RENESAS TECHNICAL UPDATE

Product Category	MPU & MCU	Document No.	TN-16C-A219A/E	Rev.	1.00
Title	Errata to R32C/161 Group Hardware Manual		Information Category	Technical Notification	
Applicable Product	R32C/161 Group	Lot No.	Reference Document	R32C/161 Group Hardware Manual Rev. 1.02 (REJ09B0517-0102)

This document describes corrections to the R32C/161 Group Hardware Manual, Rev. 1.02.
The corrections are indicated in red in the list below.

Figure 7.1 Clock Generation Circuitry

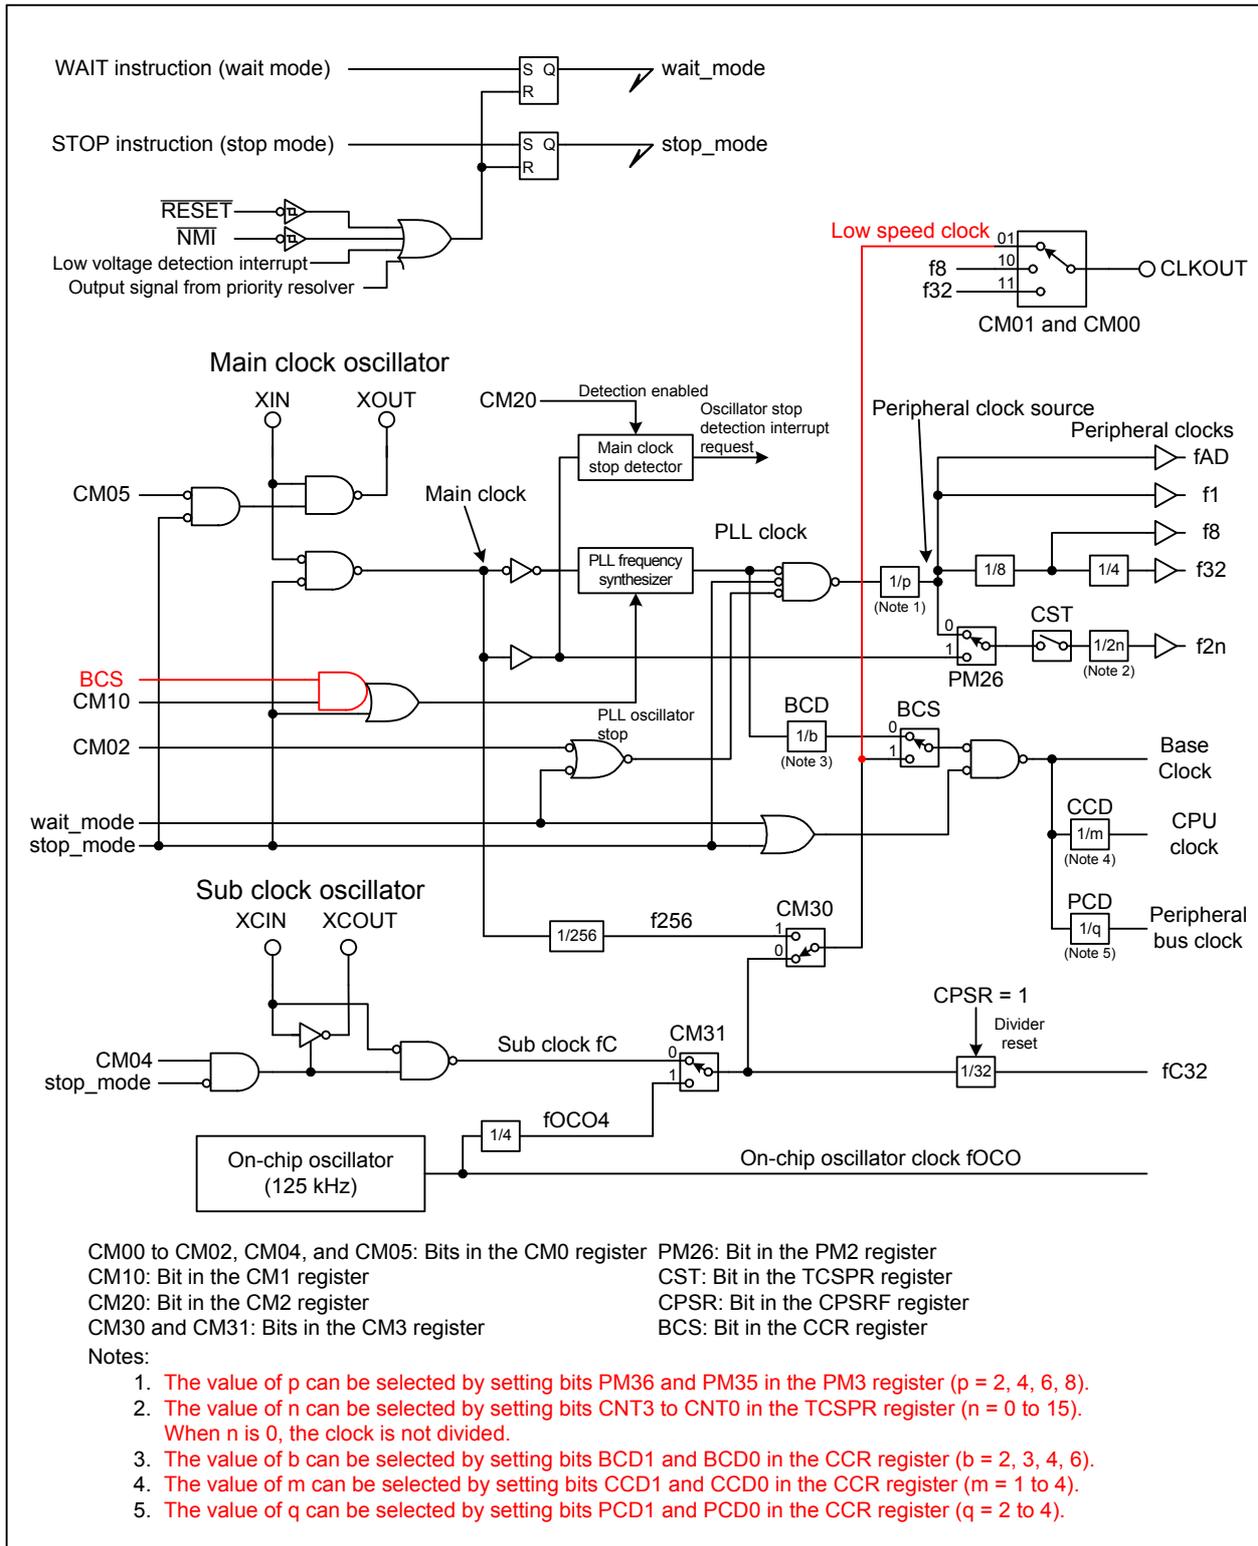
•Page 82 of 586, Figure 7.1 is corrected as follows:

Figure 10.8 Priority Resolver

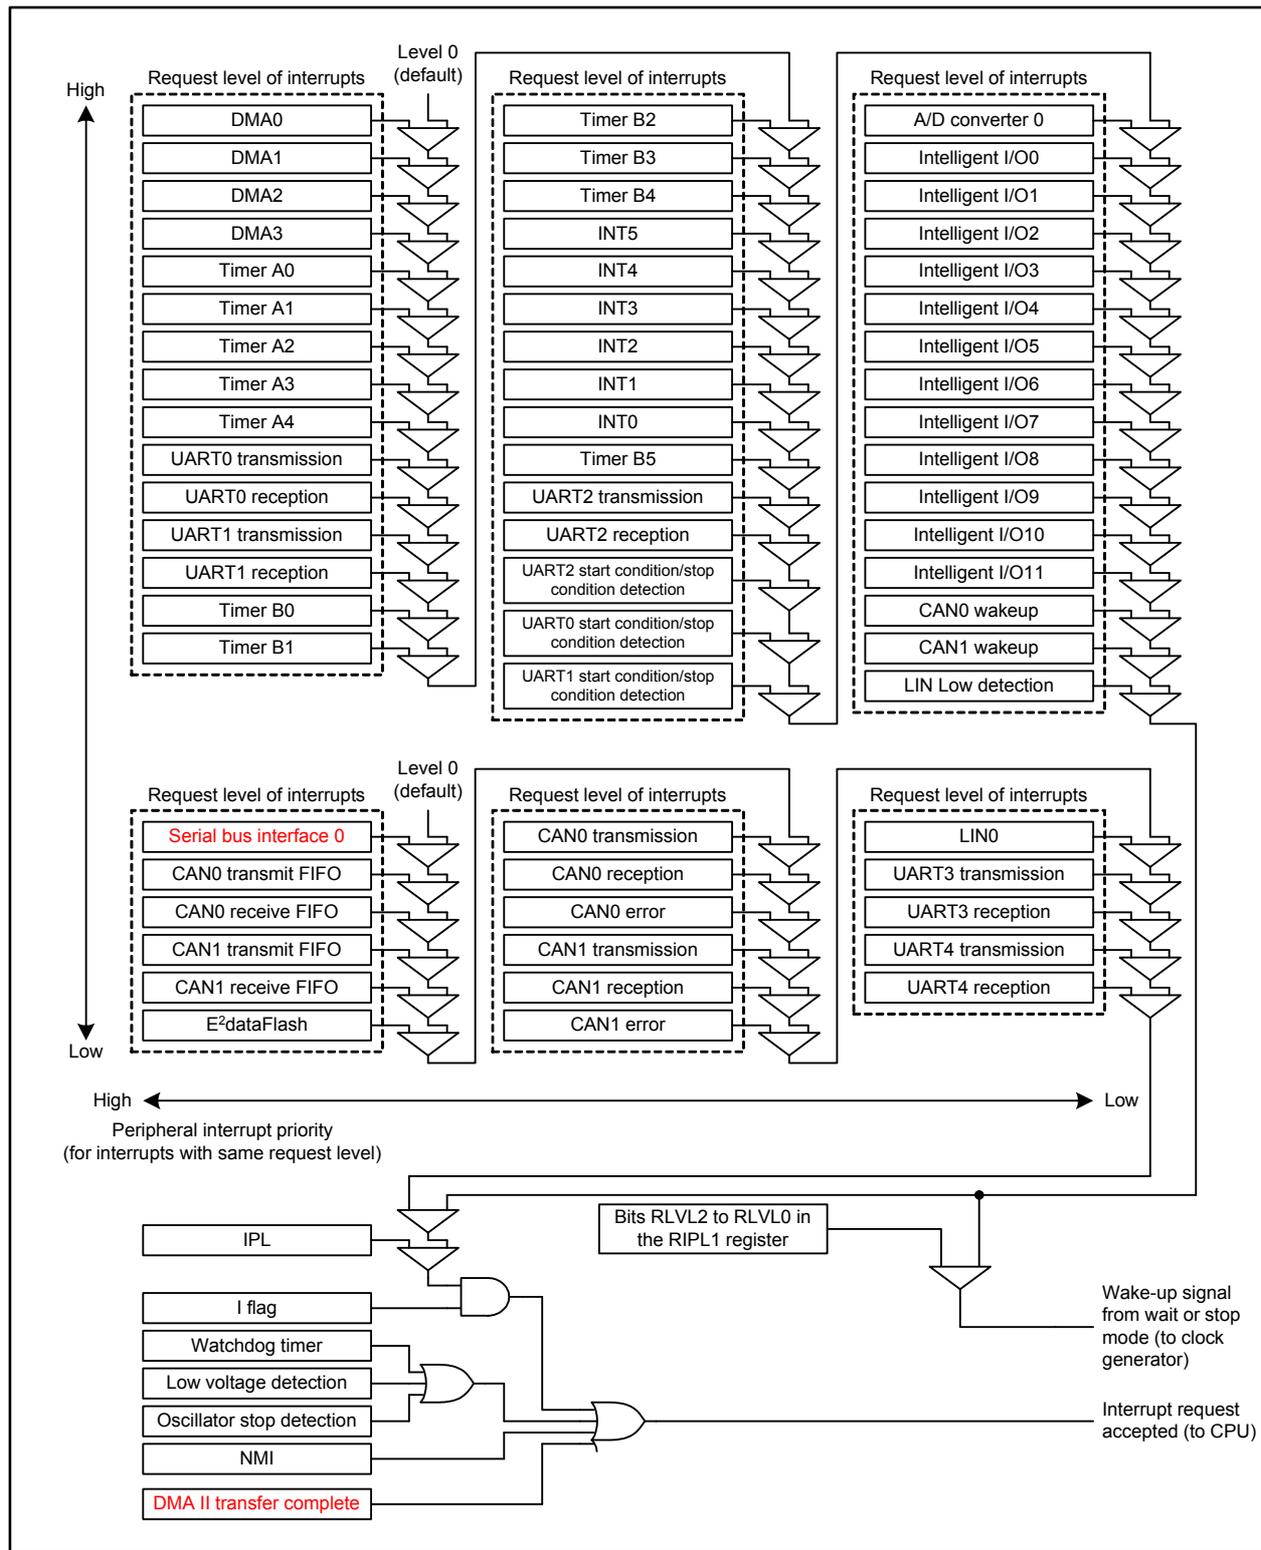
•Page 134 of 586, Figure 10.8 is corrected as follows:

(Description “Bits RLV2 to RLV0 in the RIPL2 register” and associated signal lines are deleted from Figure 10.8)

Figure 15.2 Timer B Configuration

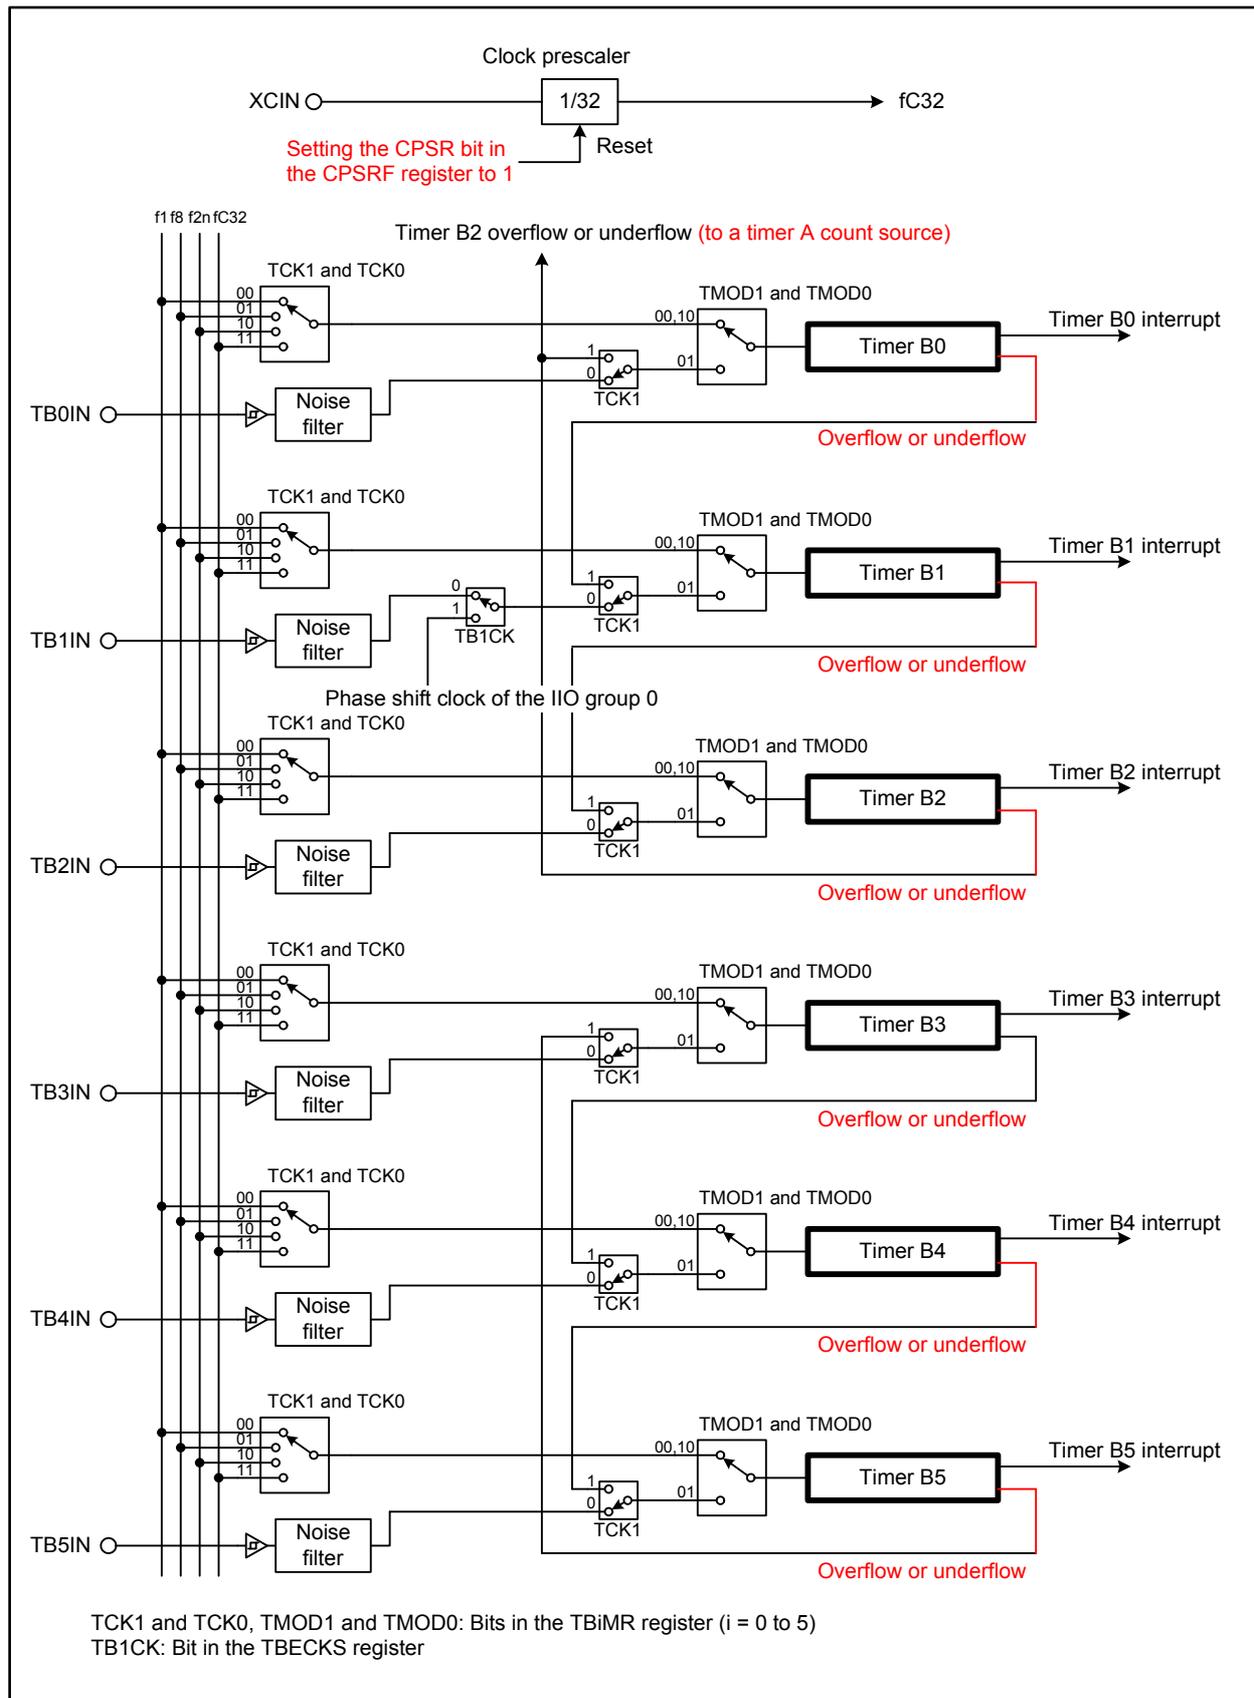
•Page 173 of 586, Figure 15.2 is corrected as follows:

Figure 19.1 CRC Calculator Block Diagram

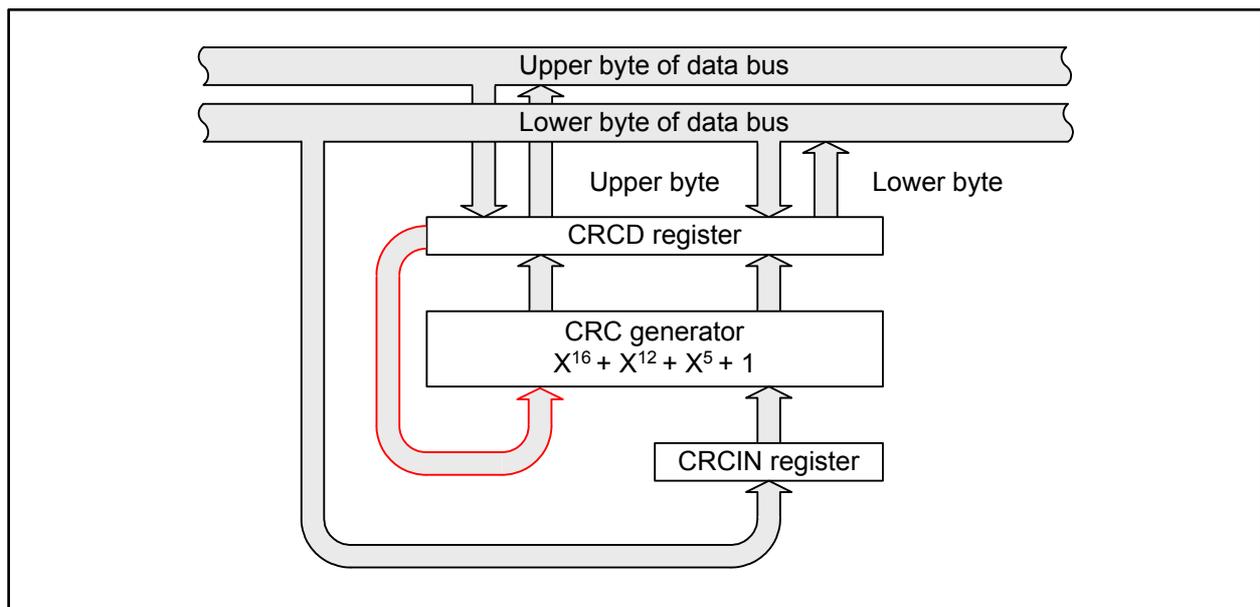
"CRC-CCITT"
- Page 292 of 586, Figure 19.1 is corrected as follows:

Figure 23.30 Example of Setting Before Transition to Wait Mode

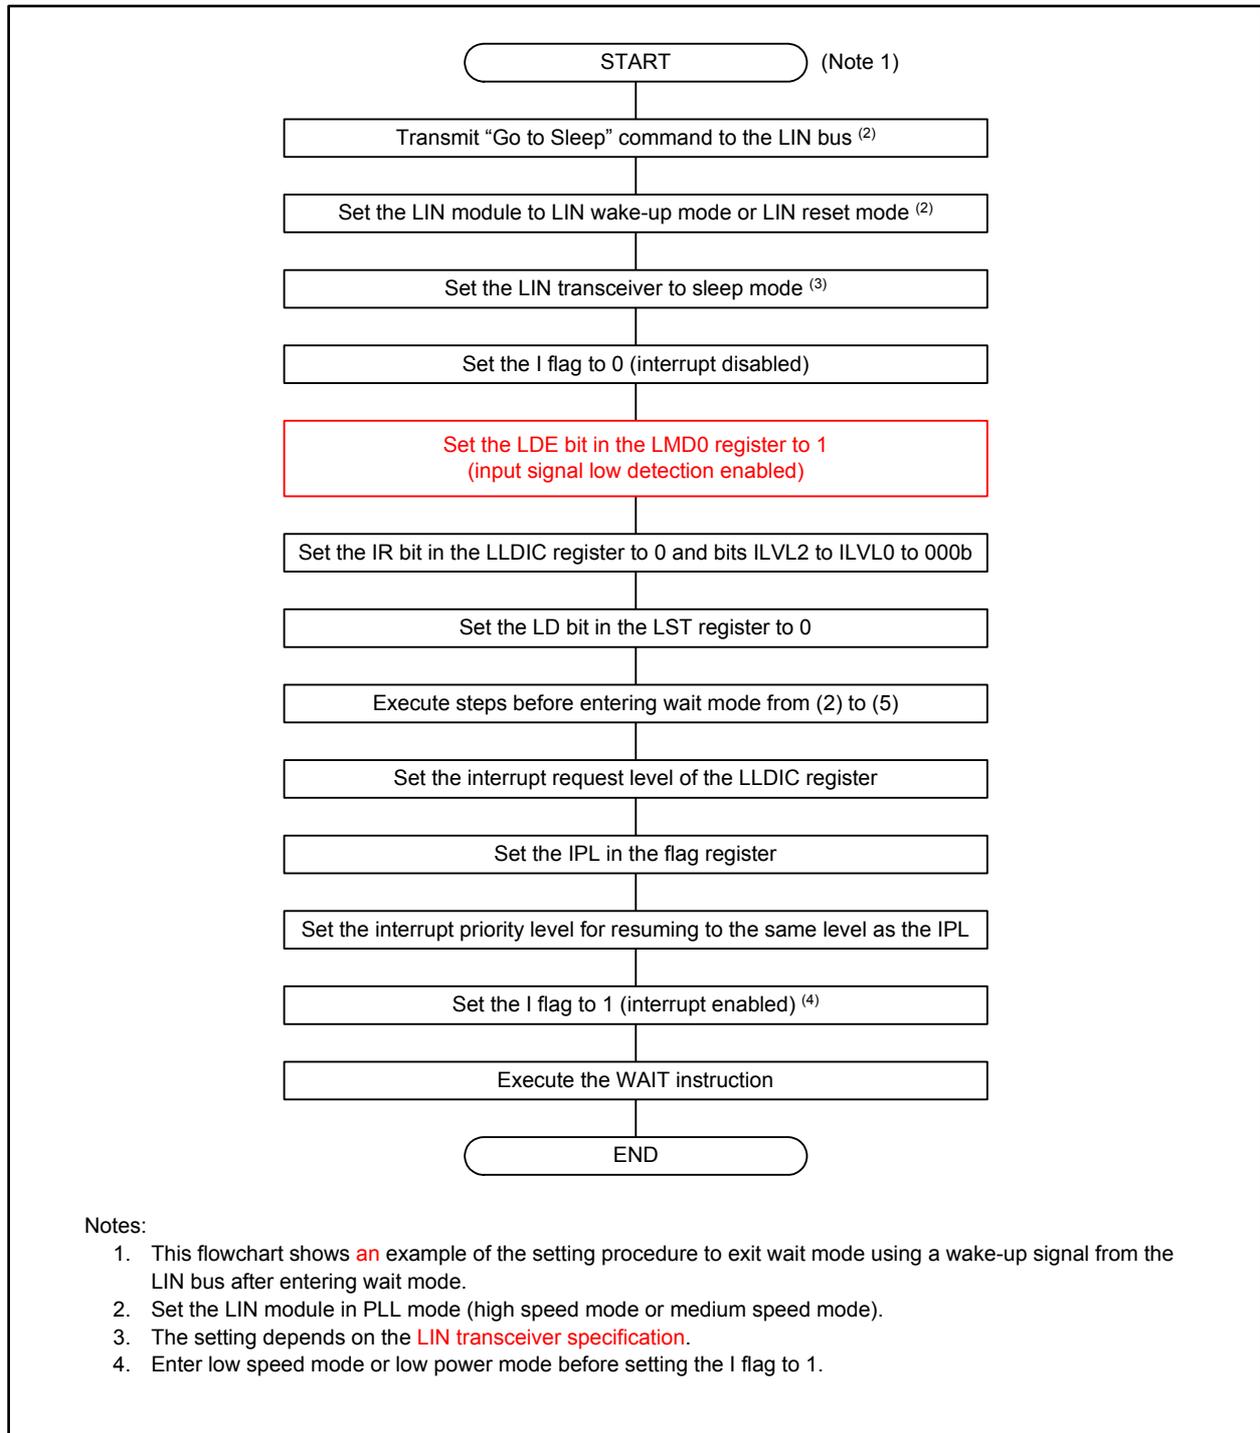
•Page 396 of 586, Figure 23.30 is corrected as follows:

Figure 23.32 LIN0 Interrupt Block Diagram

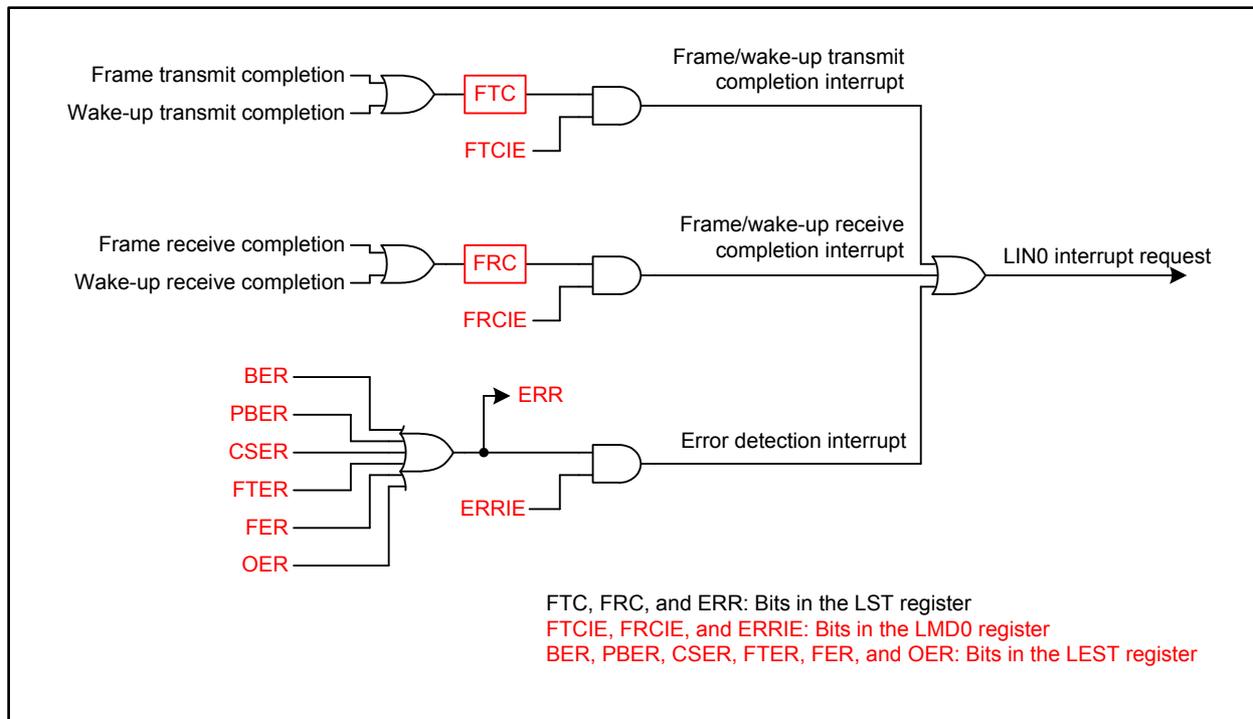
- Page 400 of 586, the following description is added to line 8 of 23.11:
 “No new interrupt request is generated by the other sources if any of them is 1 since multiple interrupt sources are aggregated.”
- Page 400 of 586, Figure 23.32 is corrected as follows:

Figure 23.33 LIN Low Detection Interrupt Block Diagram

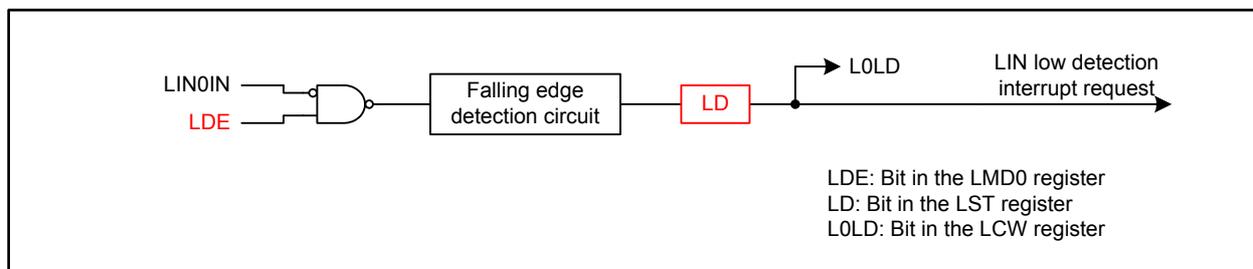
- Page 400 of 586, Figure 23.33 is corrected as follows:

Figure 25.1 Typical I/O Pin Block Diagram (i = 0 to 9; j = 0 to 7)

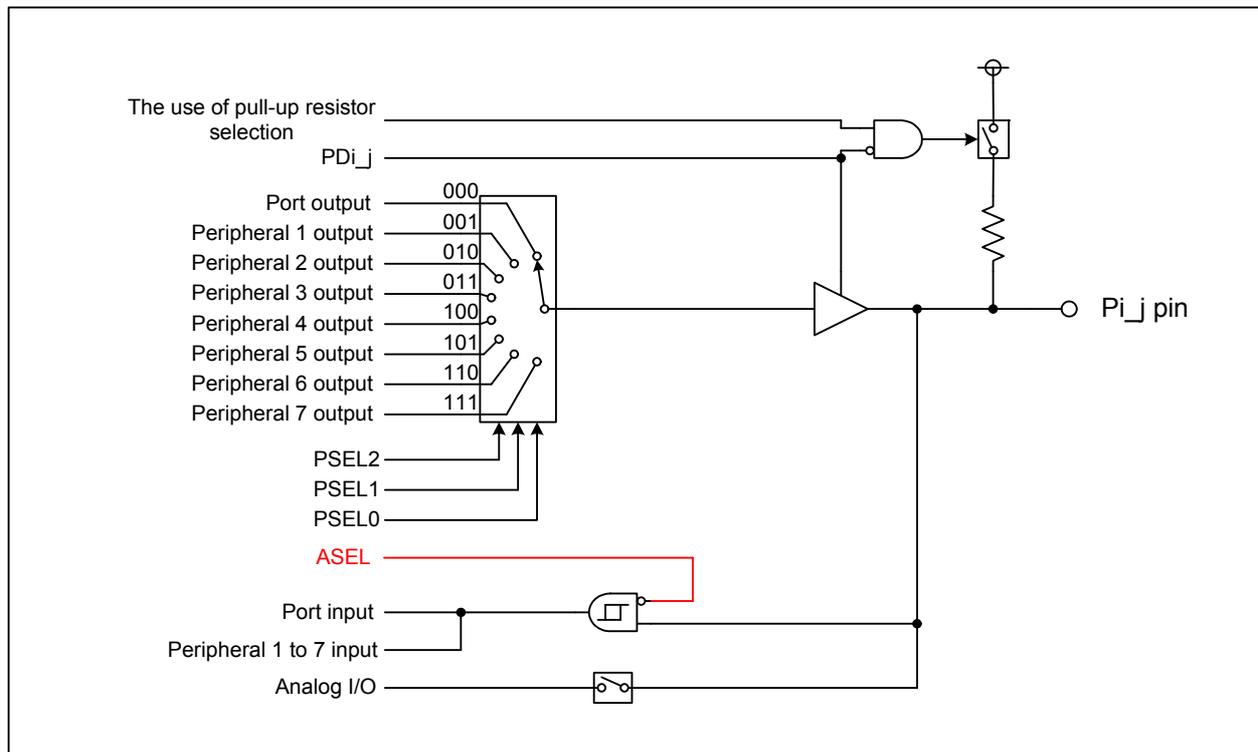
- Page 470 of 586, Figure 25.1 is corrected as follows (refer to TN-16C-A198A/E):
